SUNDRY NOTICES AND REPORTS ON WELLS

7. Unit or CA/Agreement, Name and/or No.
NMNM112723X8. Well Name and No.
EAST BLINEBRY DRINKARD UNIT 129. API Well No.
30-025-0647710. Field and Pool or Exploratory Area
EUNICE; B-T-D, NORTH11. County or Parish, State
LEA COUNTY COUNTY, NM

Apache is requesting permission to convert this well to injection, per the attached procedure and WBD's.

**Apache Corporation
East Blinebry Drinkard Unit 12
API 3002506477
May 24, 2018**

East Blinebry Drinkard Unit (EBDU) #12

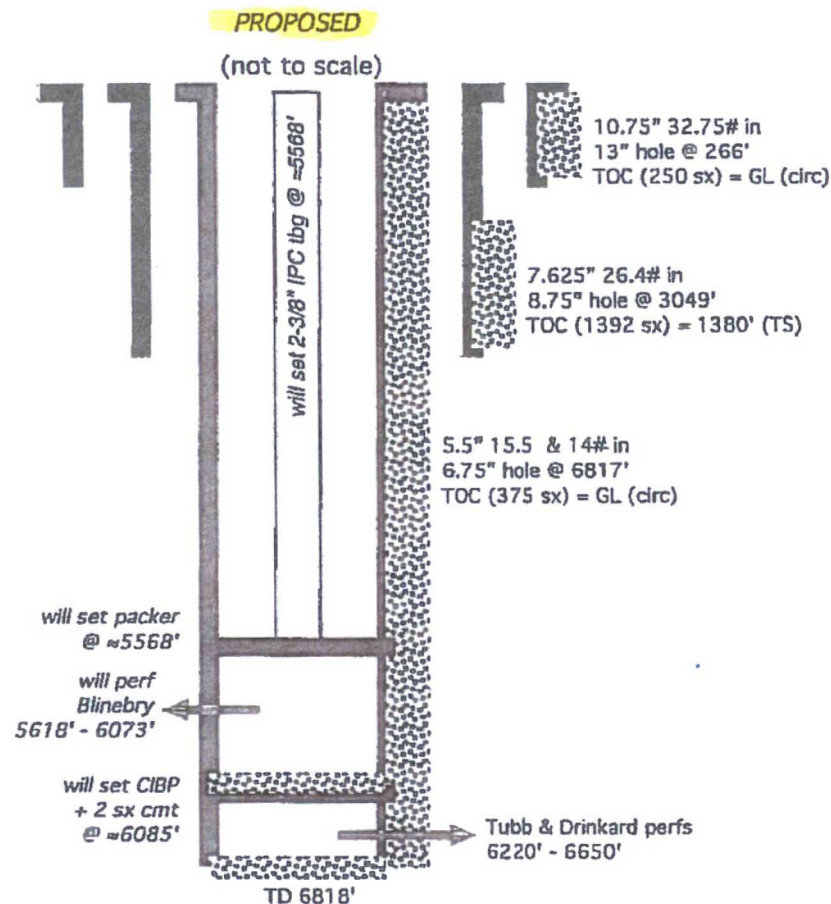
3. TIH with CIBP and work string. Set CIBP at ~6,085' and cap with ~~2 sacks of~~ ^{35' of} Class "C" cement. *or 25 sacks*
4. TOH with work string. PU and TIH with treating packer and work string. Set treating packer ~50' above existing Blinebry perforation. Load the casing with produced water. Pressure test the casing to 500 psig for 30 minutes. Release the pressure and packer. TOH with the work string and treating packer.
